To: T10 Technical Committee
From: Timothy Hogle, LSI Logic
Date: 19-April-2005
Subject: T10/05-145r0 SAS-1.1: BreakWait issue resolution

Overview

Figure 1: BREAK crossing OPEN_REJECT

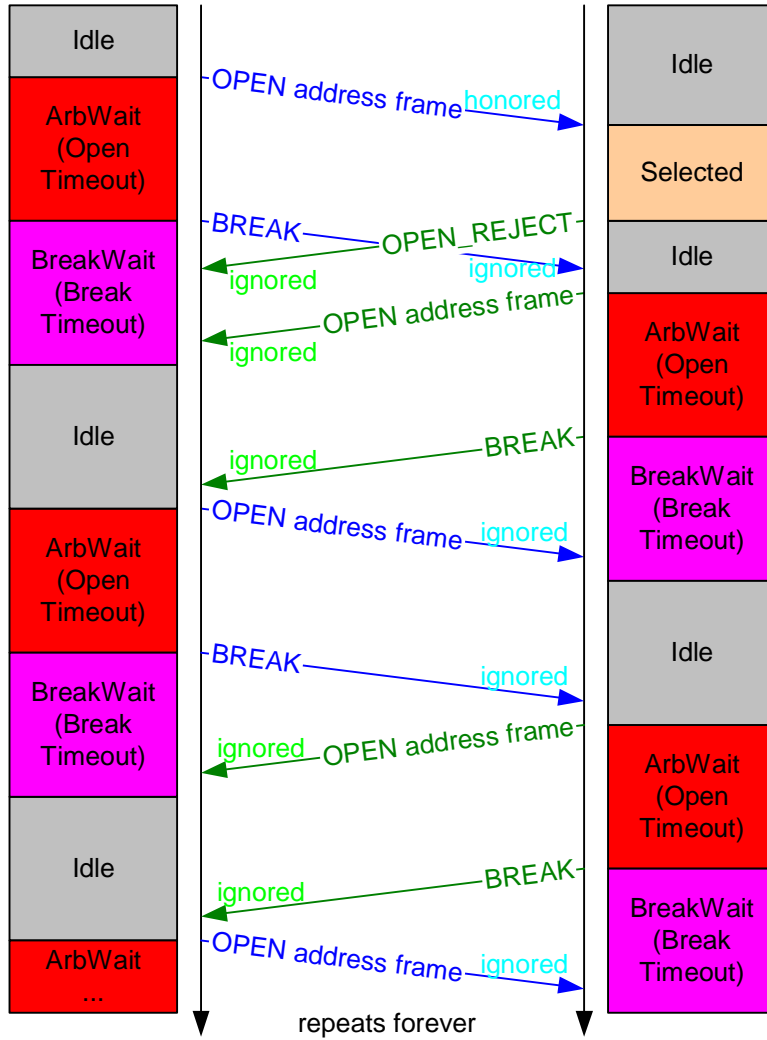
Figure 1 below (from proposal 05-086r0) demonstrates the potential of BREAK and OPEN_REJECT crossing leading to two phys ping-ponging OPENS and BREAKs forever.

Figure 2: BREAK crossing CLOSE

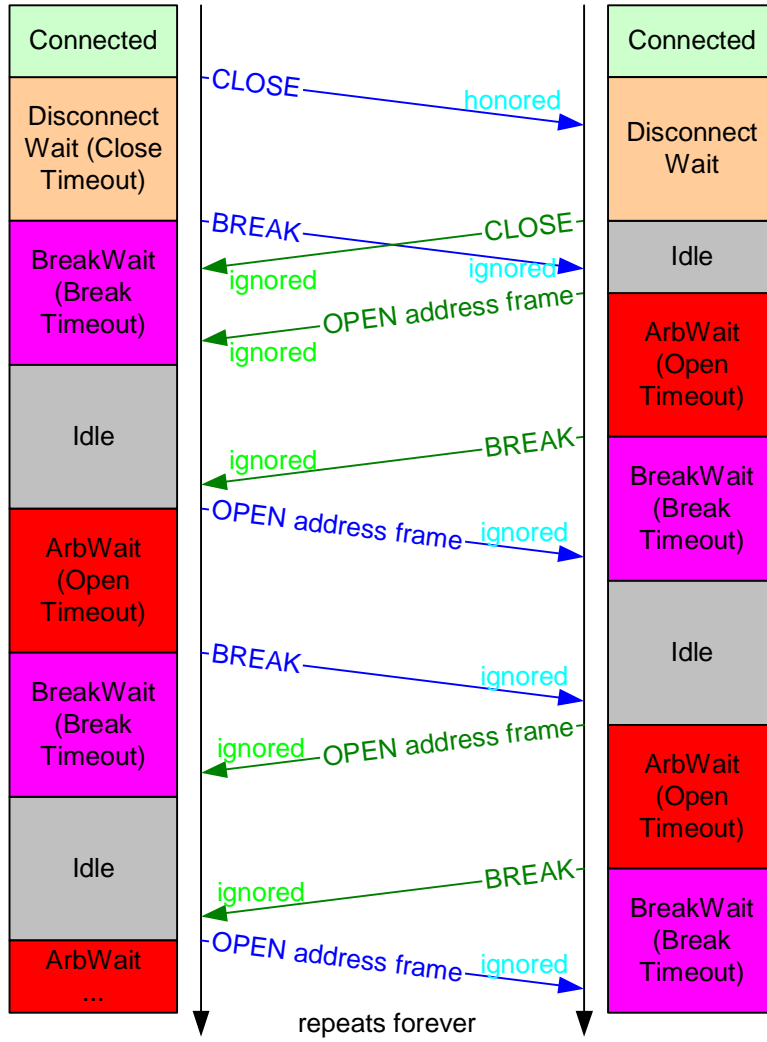
Note this ping-pong scenario can also occur when BREAK and CLOSE cross on the wire as in Figure 2.

Figure 3: Transition to Idle when OPEN_REJECT received in BreakWait

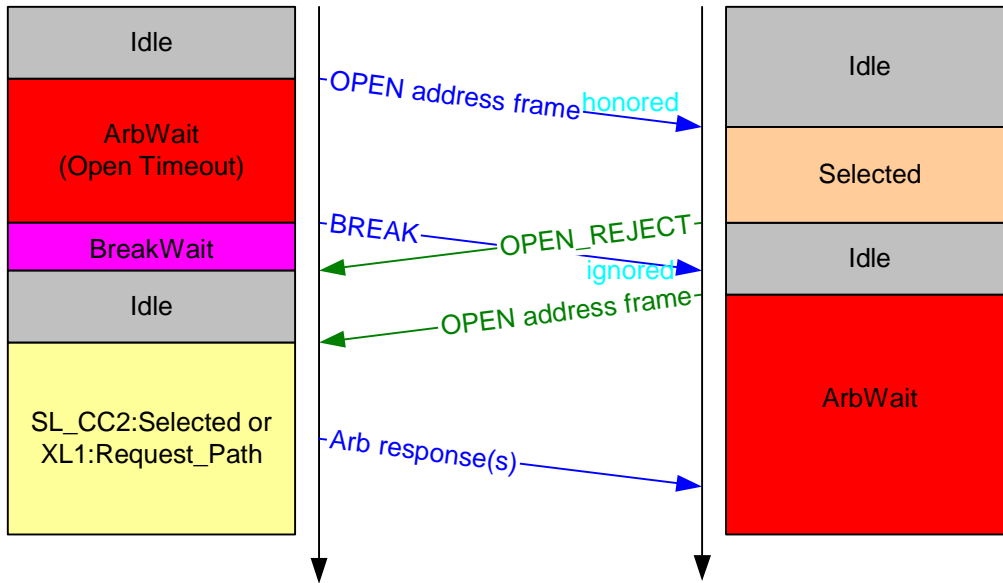
Proposal 05-040r0 suggested that the left-hand phy transition from BreakWait to Idle upon reception of OPEN_REJECT to prevent this loop as demonstrated in Figure 3.

An identified shortcoming of the method shown above is that it can degenerate into the ping-pong cases if the OPEN_REJECT primitive or CLOSE primitive sequence are subjected to bit errors and therefore not properly received.

Figure 4: Transition to Idle when CLOSE received in BreakWait

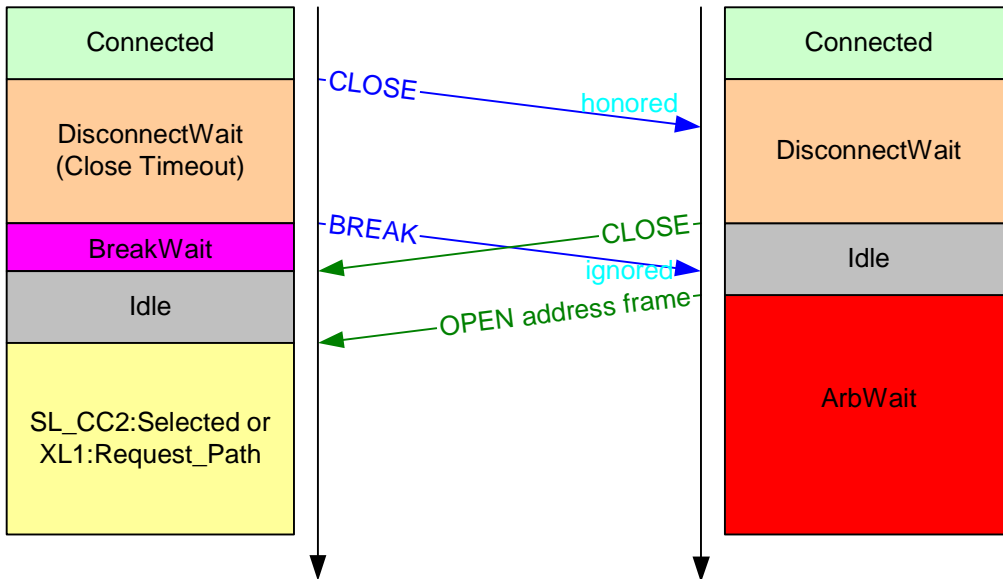
Note that while 05-040r0 did not address it, this method could be extended to cover the BREAK crossing CLOSE case as shown in Figure 4.

Figure 5: OPEN_REJECT(RETRY) response to OPEN address frame while in BreakWait

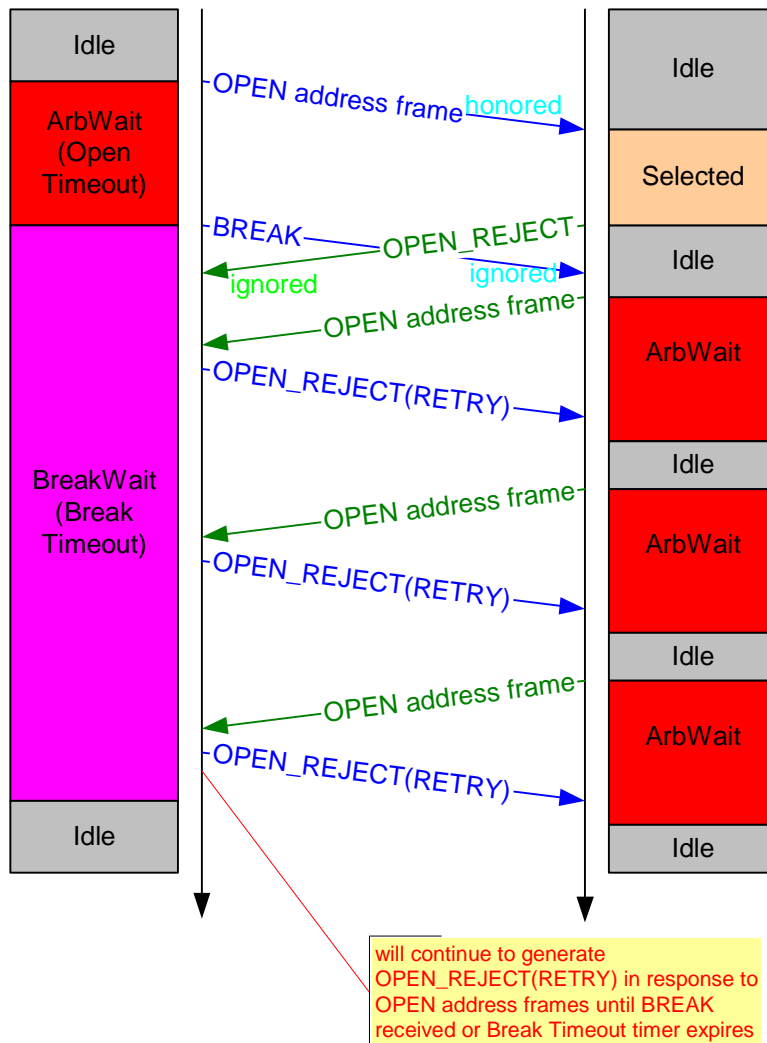
Proposal 05-093r1 sought to remedy the above described link layer race conditions by causing a SAS device in the BreakWait state respond to a received OPEN address frame with OPEN_REJECT(RETRY) if an end device or with OPEN_REJECT(WAITING FOR BREAK) if an expander device as illustrated by Figure 5.

While this method prevents any link layer race conditions for BREAK crossing either OPEN_REJECT or CLOSE, it unfortunately does more harm than good when BREAK crosses an OPEN address frame as illustrated by Figure 6 and subsequent description.

Figure 6: Issues introduced by 05-093r1 OPEN_REJECT while in BreakWait

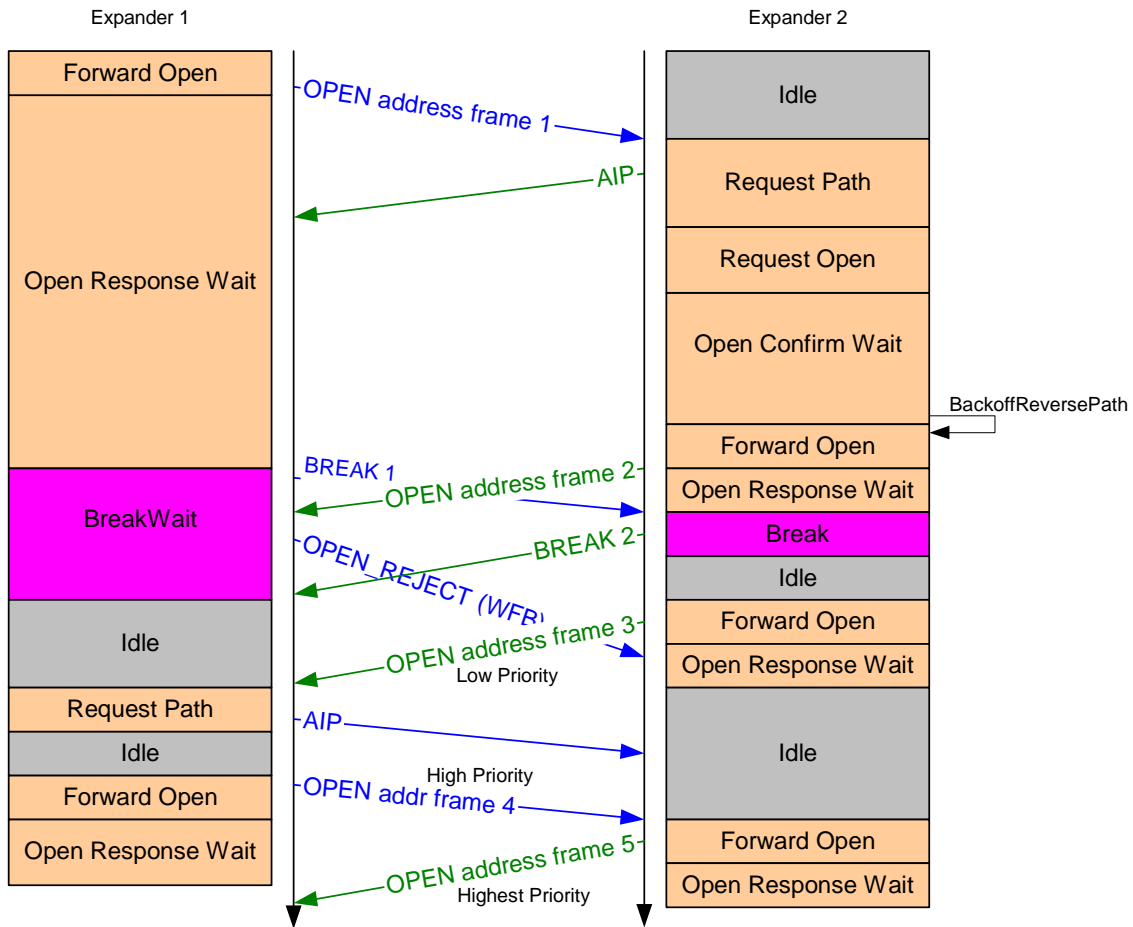
Note that while a BackoffReversePath case is shown, other scenarios could also lead to similar results such as lost arbitration.

Expander 1 sends Break #1 coincident with Expander 2 sending OPEN address frame #2.

Thereafter in accordance with 05-093r1, Expander 1 sends OPEN_REJECT(WAITING FOR BREAK) in response to received OPEN address frame #2 but coincidentally with Expander 2 sending BREAK #2.

- Expander 2 considers BREAK #1 to apply to OPEN address frame #2
- Expander 1 considers BREAK #2 to terminate the connection request associated with OPEN address frame #1
- Endpoints at either end properly consider OPEN address frame #1 and #2 as terminated

However, Expander 2 has already begun to forward OPEN address frame #3 at the time it receives/recognizes OPEN_REJECT(WAITING FOR BREAK).

- Expander 2 will terminate the connection request associated with OPEN address frame #3 due to the OPEN_REJECT(WAITING FOR BREAK).
- Expander 1 will consider OPEN address frame #3 as a valid connection request and arbitrate for path resources.

Expander 1 arbitrates which leads to one of the following, depending on the arbitration priority of OPEN address frame #3:

1. Expander 1 ArbWon cases
 - a) OPEN_ACCEPT transmitted to idle Expander 2
→ Expander 2 will ignore the OPEN_ACCEPT – endpoint should timeout
 - b) OPEN_ACCEPT transmitted to Expander 2 forwarding an OPEN address frame
→ **OPEN_ACCEPT will be misrouted**
2. Expander 1 ArbLost cases
 - a) OPEN address frame #4 > OPEN address frame #5
→ Expander 2 will correctly backoff
 - b) OPEN address frame #4 < OPEN address frame #5
→ neither expander will backoff – OPEN timeout at endpoint should resolve
3. Expander 1 ArbReject cases
 - a) OPEN_REJECT(any) sent to idle Expander 2
→ Expander 2 ignores
 - b) OPEN_REJECT crosses OPEN address frame
→ **Expander 2 associates the OPEN_REJECT with the wrong OPEN address frame and the potential to repeat this cycle indefinitely exists.**

Because of the potential for the OPEN_REJECT(RETRY) or OPEN_REJECT(WAITING FOR BREAK) to be associated with the wrong OPEN address frame, proposal 05-093r1 is deemed too problematic to remain within SAS-1.1.

Figure 7: BREAK crossing OPEN address frame without OPEN_REJECT response

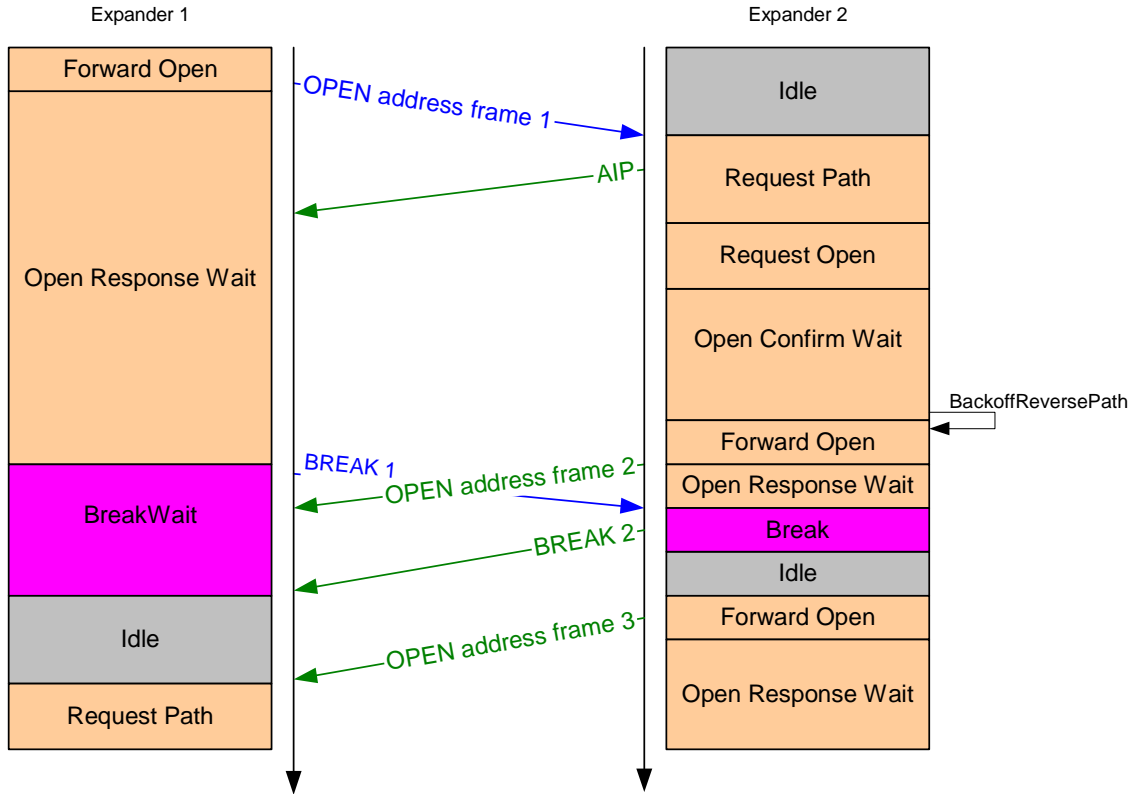
Note that without the OPEN_REJECT(RETRY) or OPEN_REJECT(WAITING FOR BREAK) response to an OPEN address frame while in the BreakWait state, no problem exists when OPEN address frames cross with BREAK as illustrated in Figure 7.

Note that in this case there is no disagreement about the state of any of the connection requests (OPEN address frames) by either expander – the disagreement is introduced by the OPEN_REJECT in 05-093r1.

Figure 8: BREAK_RESPONSE following BREAK crossing OPEN_REJECT

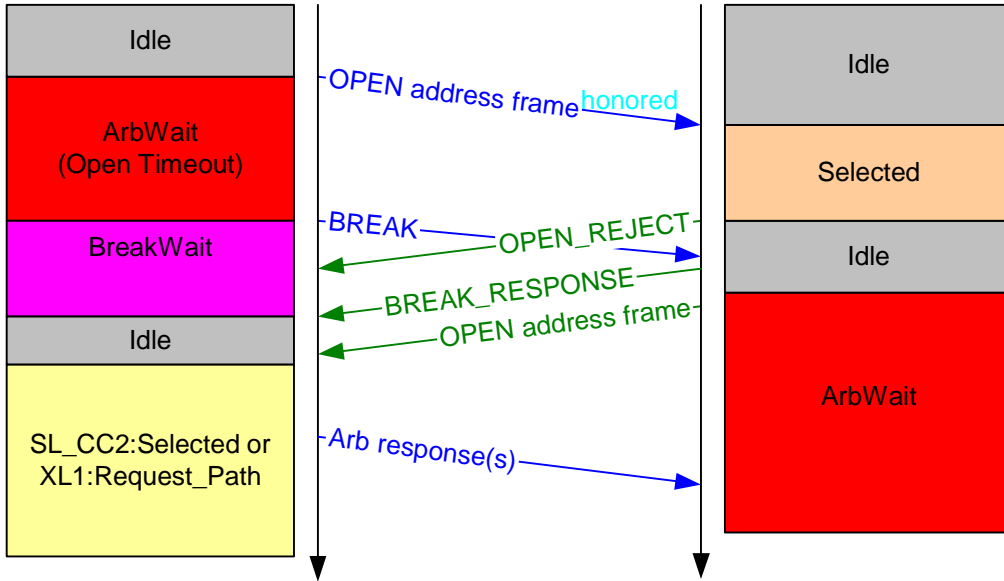
Figure 8 shows how the BREAK_RESPONSE solves the BREAK crossing with OPEN_REJECT.

Figure 9: BREAK_RESPONSE following BREAK crossing CLOSE

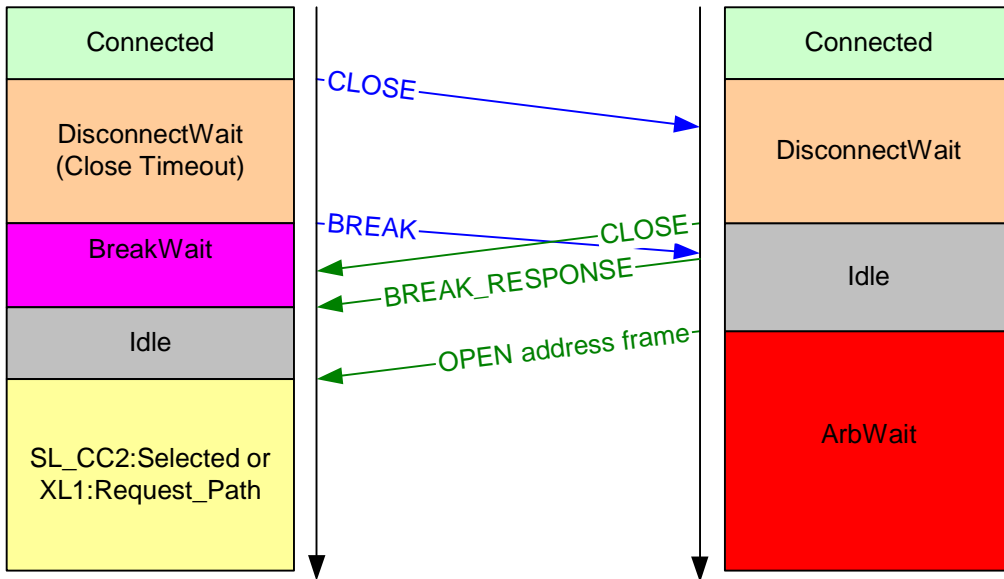
Figure 9 shows how the BREAK_RESPONSE solves the BREAK crossing with CLOSE.
